## TECHNICAL BULLETIN

**MODIFICATION PROCEDURES  
FOR  
FLIGHT COORDINATION CENTRAL  
AN/TSC-61B  
(NSN 5895-01-057-3968) (EIC: JP4)  
TO INCORPORATE  
SINGARS RADIOS**

Technical Bulletin  
 No. 11-5895-469-30

This Technical Bulletin (TB) contains instructions for changes to the AN/TSC-61B that will allow SINGARS RADIOS to function correctly when installed.

Figure 2. Radio-Audio Control Panel (C-10417/TS)

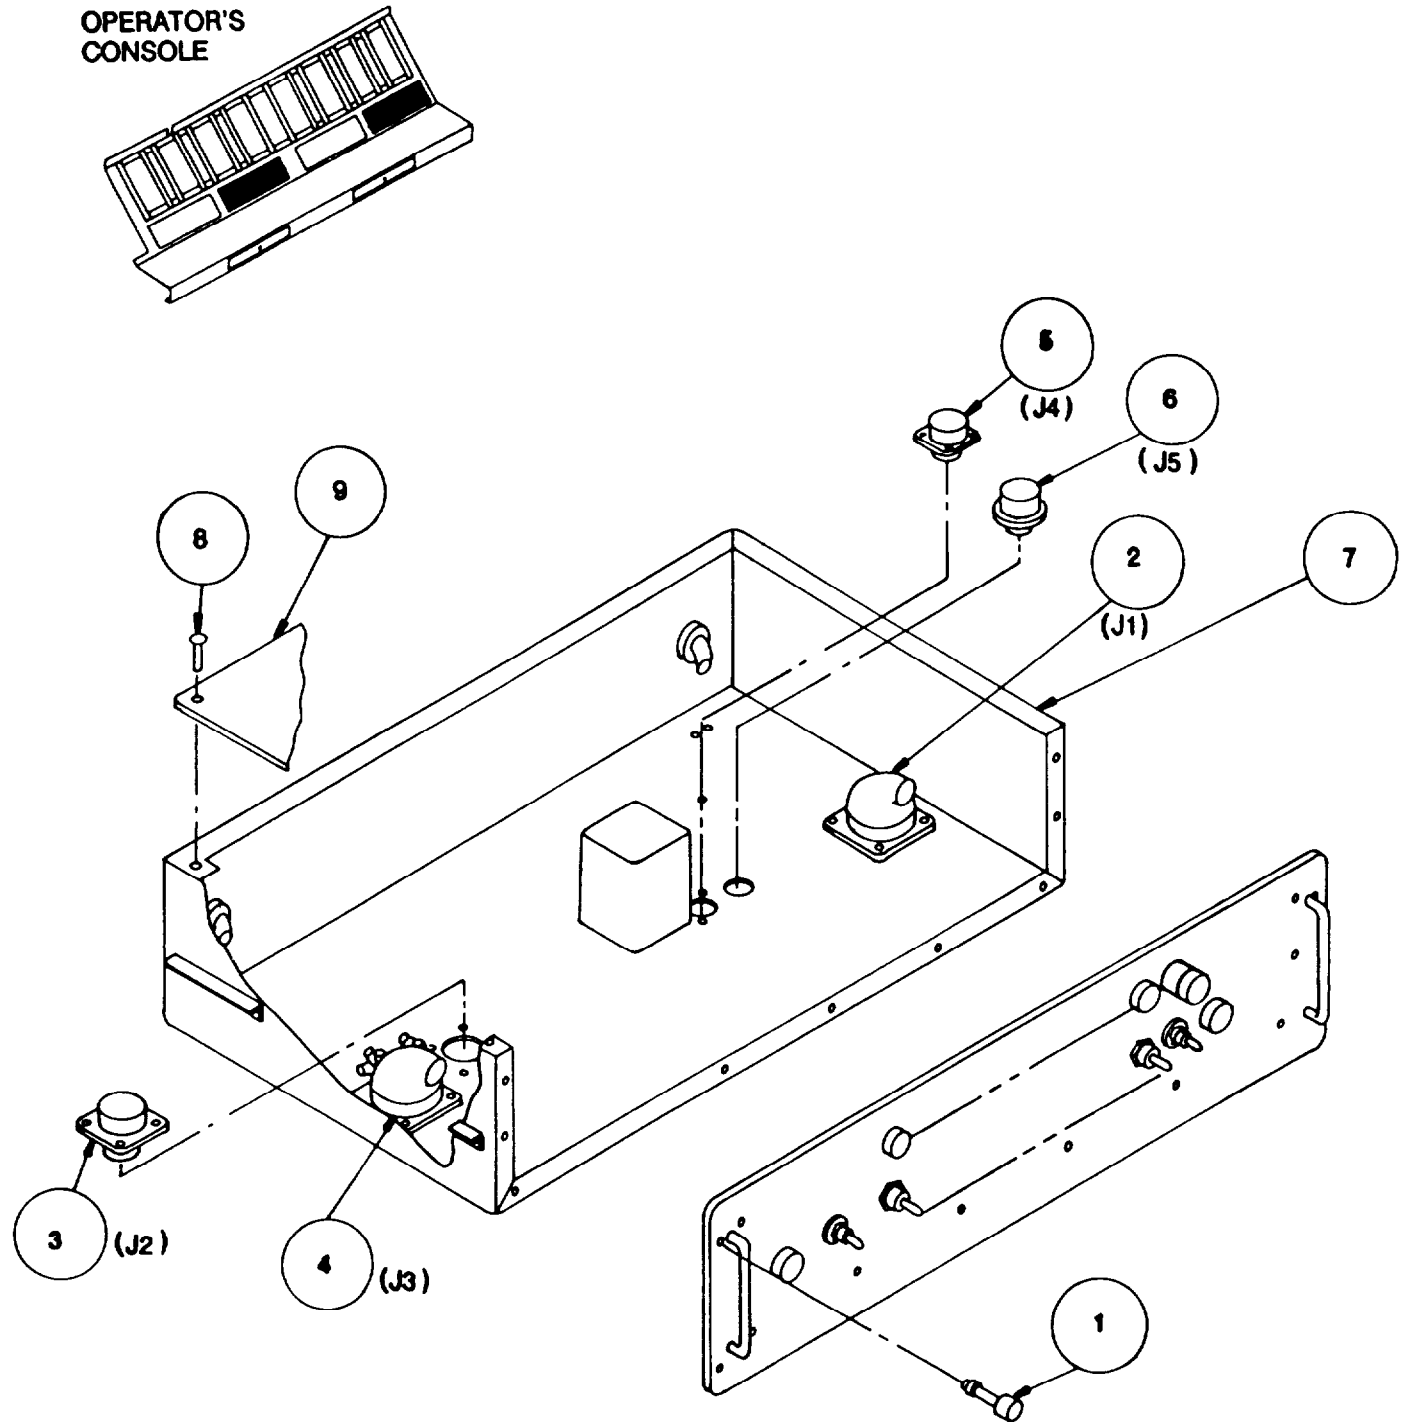
1. Turn the four (1) captive screws on the front of the Radio-Audio Control Panel counterclockwise to release it from the Flight Status or Supervisor console. (see Figure 2)

2. Disconnect cable assemblies from connectors J1(2), J2(3), J3(4), J4(5) and J5(6) on the Radio-Audio Control Panel (7).
3. Remove the Radio-Audio Control Panel (7) to clean flat location.

4. Unscrew the four cross-tip screws (8) from the top cover (9) and lift the cover out of the way.
5. Remove front panel knob (10) from the FM1 switch (11) by turning the knob counterclockwise. (see Figure 3)

17. Change the part number from SC-B-881153 to SC-B-881153-1 on the Radio-Audio Control Panel (7) and Part Number SC-D-881528 to SC-D-881528-1 on Panel Assembly.

Figure 3. Panel Assembly (SC-D-881528)

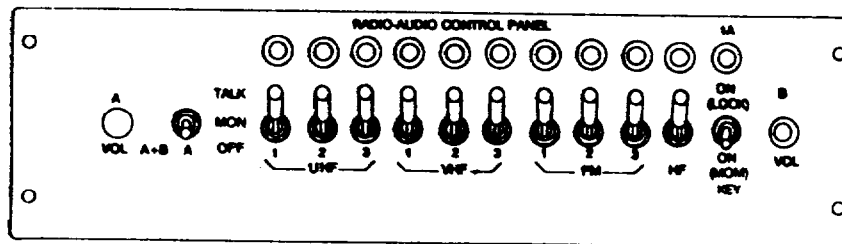
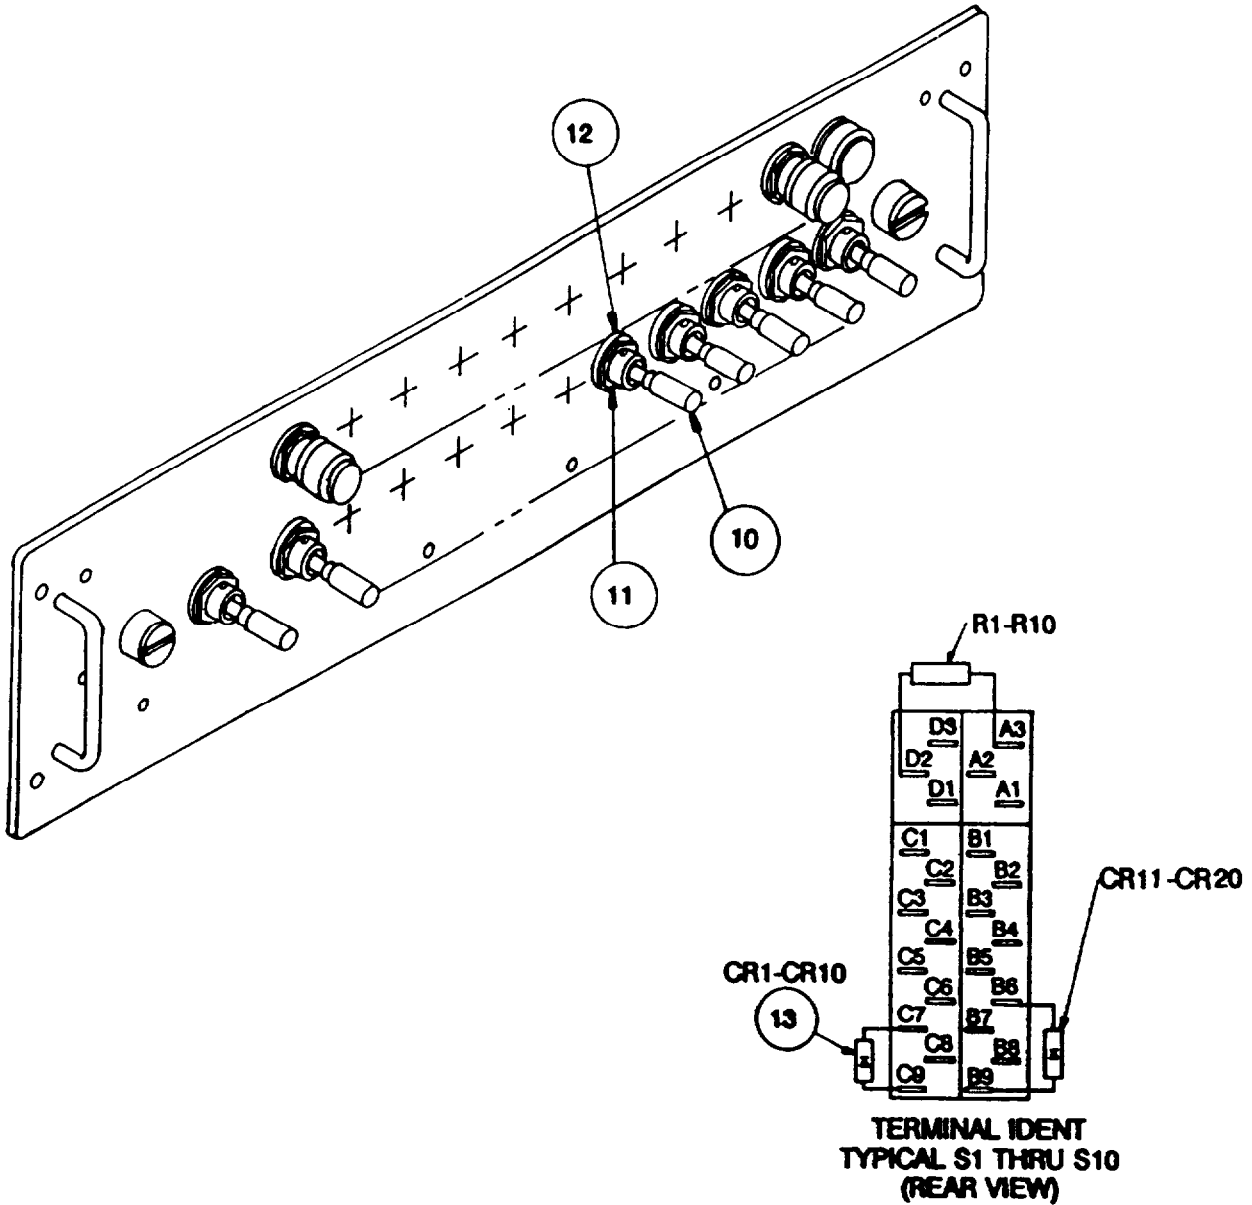
6. Remove lock nut (12) from the FM1 switch (11) with adjustable wrench.
7. Push the FM1 switch (11) back through the mounting hole and lift and rotate the switch to locate diode CR1 (13) to be removed.

8. Identify diode CR1 (13) which is connected to Pins C7 and C9 contacts of the FM1 switch (11) with wires color coded violet and yellow.
9. Remove the body of diode CR1 (13) by cutting with a pair of diagonal pliers.

10. Connect the remaining pigtailed of diode CR1 (13) together with a pair of long nose pliers.
11. Solder the pigtailed together.
12. Reinstall the FM1 switch (11) by rotating the switch back to its original position and pushing it through the front mounting hole.

Figure 4. Box Signal Control Assembly (Part Number SC-D-881184)

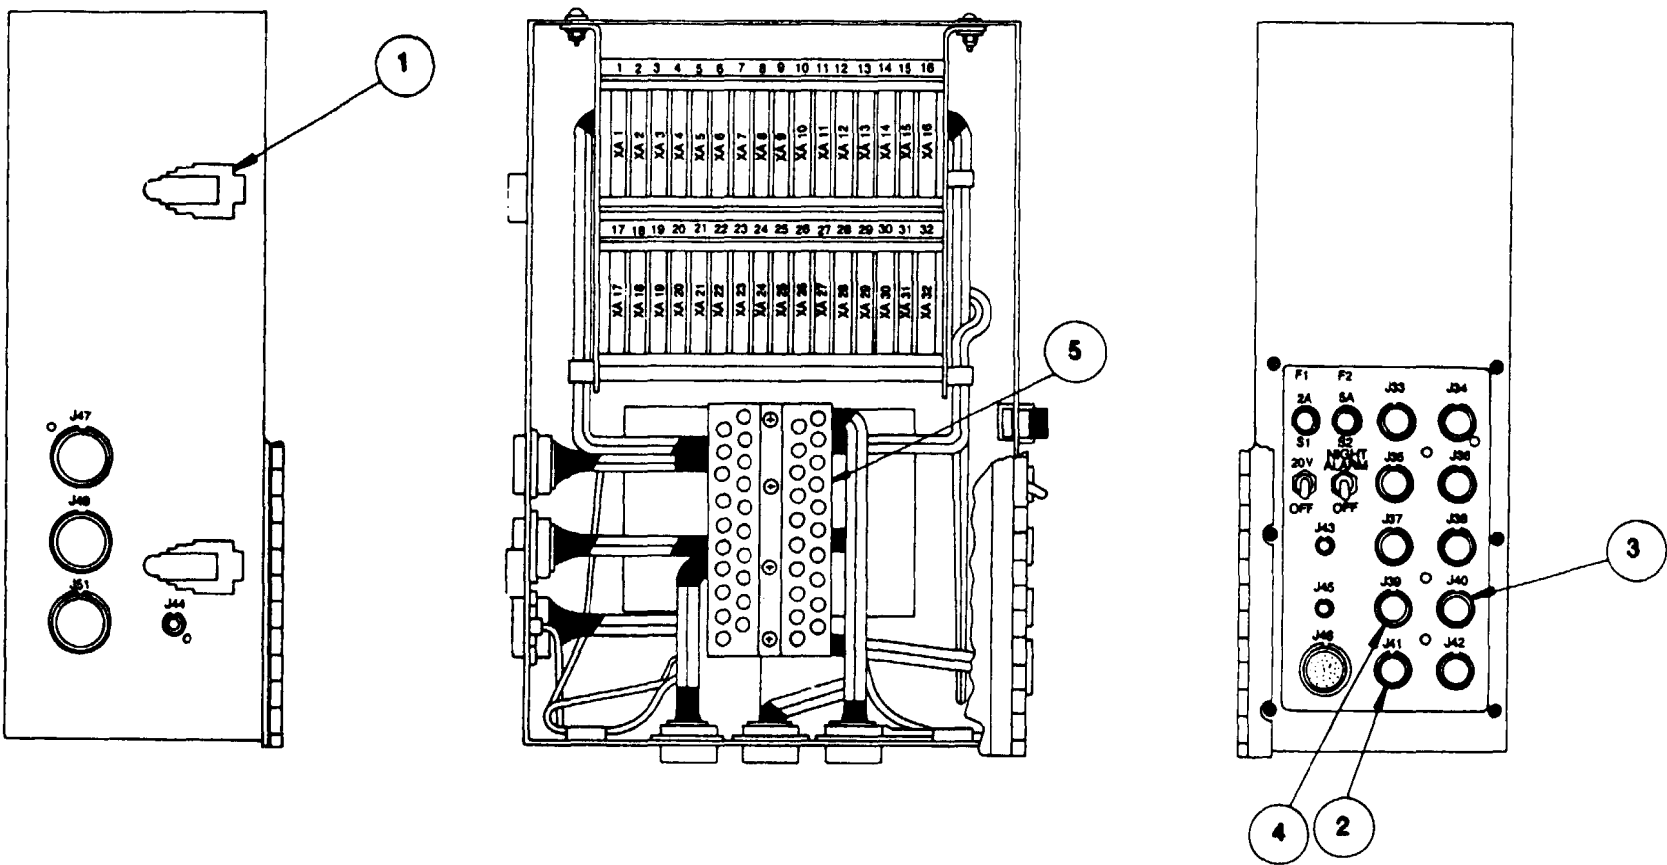
1. Release the two locking clips (1) that hold the cover closed.
2. Open the cover of the Box Signal Control Box Assembly.
3. Unscrew the connector collar on J40 inside the signal control box. Pull out collar and rubber sleeving far enough to expose the wire connections. Identify pin E (violet color coded wire).

4. Remove 1/2" of insulation from each end of additional eight inch piece of violet color coded wire and solder one end onto Pin E connection. Feed free end of wire through rubber sleeve and connector collar.

5. Connect free end to Pin 9 on TB1 (5) by crimping with long nose pliers and soldering in place.
6. Repeat steps 4 and 5 for J39 and J41. Connect J39 violet color coded wire to Pin 10 on TB1 (5) by crimping with long nose pliers and soldering in place. Connect J41 violet color coded wire to Pin 56 on TB1 (5) by crimping with long nose pliers and soldering in place.

7. Change the part number from SC-D-881184 to SC-D-881184-1.
